EXHIBIT A

VIEW STUDY FOR HILLSIDE DEVELOPMENT PERMIT PROJECT NO. 26-0000888

Located at 420 South Sunset Canyon Drive, Burbank CA 91501

Figure 3: Site plan of the proposed Project, which includes the new retaining walls ranging in height of 2'-6" to 4'-0".

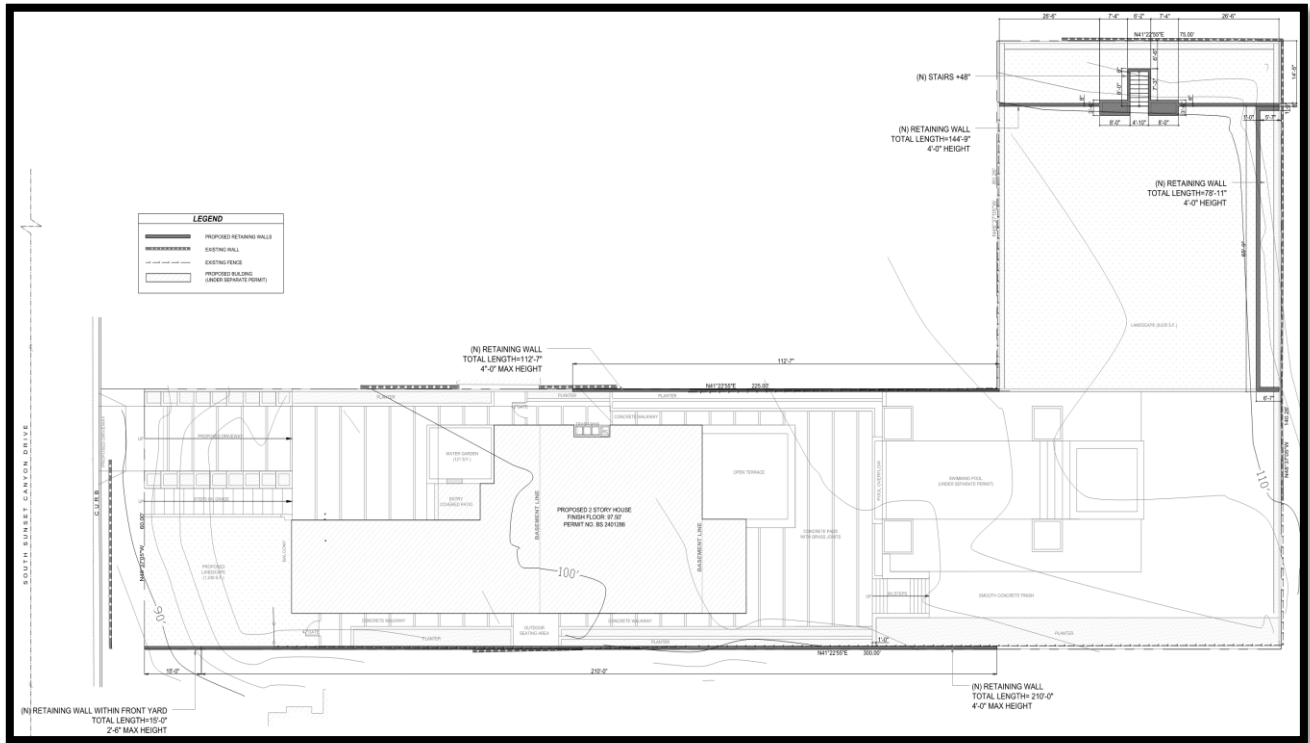
The Project proposes to construct 561 feet of new retaining walls ranging from 2'-6" to 4'-0" in height. Figures 3 and 4 below, provide the proposed improvements to the Project. Also, a 3'-0" concrete wall will be constructed above the new 4'-0" retaining walls outside of the front yard area.

Figure 7: View of the current conditions of the lot facing north.

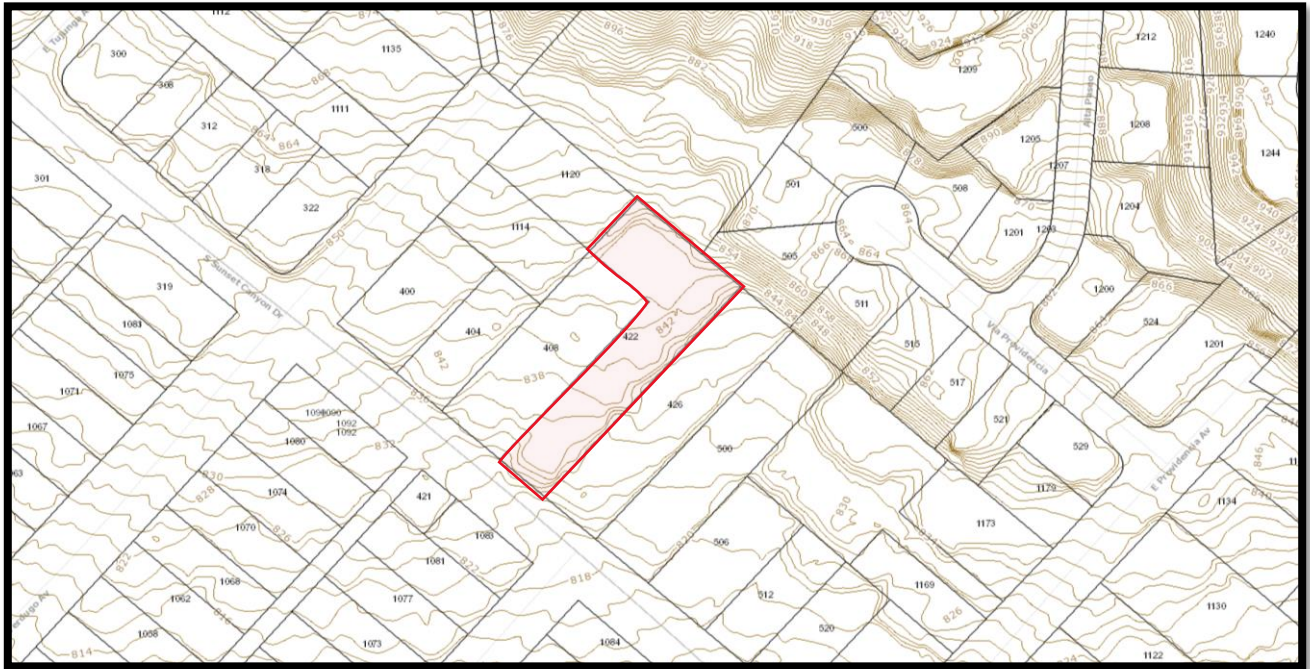
The Project site is currently under construction to build a new single-family dwelling and garage. Portions of structures have been constructed on the site as shown in figure 7. The new single-family dwelling was approved separately for a Hillside Development Permit to demolish an existing single-family dwelling and garage and construct a new two-story, 7,037 square-foot single family residence with swimming pool, spa, and rear trellis located in the R-1 (Hillside) zone.

The new proposed retaining wall located on the front yard area on the southeastern property line abutting property 426 S. Sunset Canyon Drive, as shown in Figure 8, is proposed to be 36'-0" in length and will not exceed 2'-6" in height within the front yard area.

The new proposed retaining wall along the front yard area continues 189'-0" north along the southeastern property line abutting property 426 S. Sunset Canyon Drive, as shown in Figure 9. The height of this retaining wall will not exceed 4'-0" in height and a new proposed 3'-0" concrete wall will be placed on top of the new retaining wall with an overall maximum height of 7'-0" tall.

The new proposed retaining walls at the rear of the property line looking towards property 1120 E. Verdugo Avenue & 501 Via Providencia are proposed to be 220'-5" in length and will not exceed 4'-0" in height, as shown in Figure 10.

The new proposed retaining wall located on the northwest interior property line abutting property 408 S. Sunset Canyon Drive is proposed to be 112'-7" in length and 4'-0" in height and a new proposed 3'-0" concrete wall will be placed on top of the new retaining wall with an overall maximum height of 7'-0" tall as shown in Figure 11. In accordance with the R-1 zone retaining wall standards, walls may be constructed on top of retaining walls, which are located outside the front yard area. The overall height of the retaining wall plus the block wall on top of the retaining wall also complies with the height standard for standalone block wall located outside the front yard.

Based on staff review and analysis of the submitted site plan, architectural drawings, topographic information, site photographs, and the site visit conducted on June 10, 2026, staff determined that the proposed Project will not result in any unreasonable obstruction of primary or secondary views for properties within the surrounding neighborhood.
